Application No. 10/630,292
Amendment dated August 26, 2005
Reply to Office Action of August 2, 2005

Amendments to the Drawings:

FIG. 3

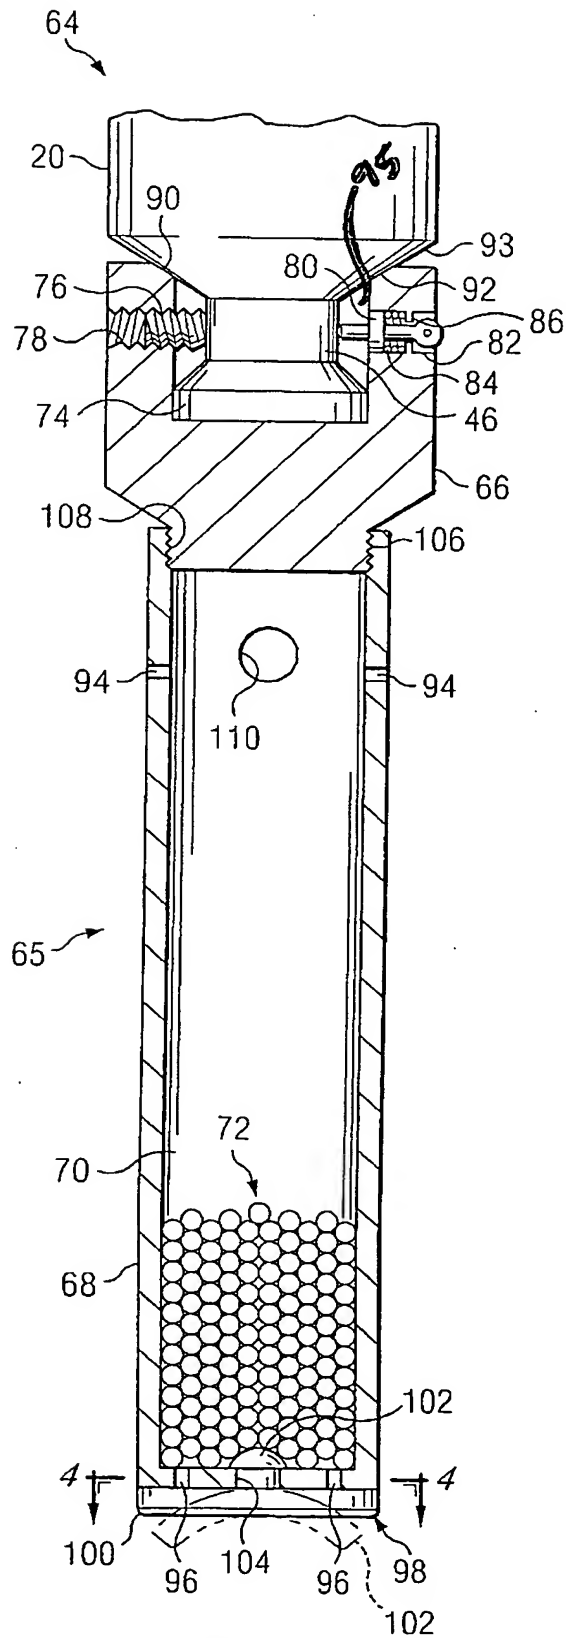
The attached sheet of drawings includes changes to Figs. 3 and 6. The change to Figure 3 adds reference number for the opening 95. The change to Figure 6 adds reference number 135 for the wall. The amendments to the drawings do not add any new matter, as all the amendments are supported by the original specification, claims, and drawings.
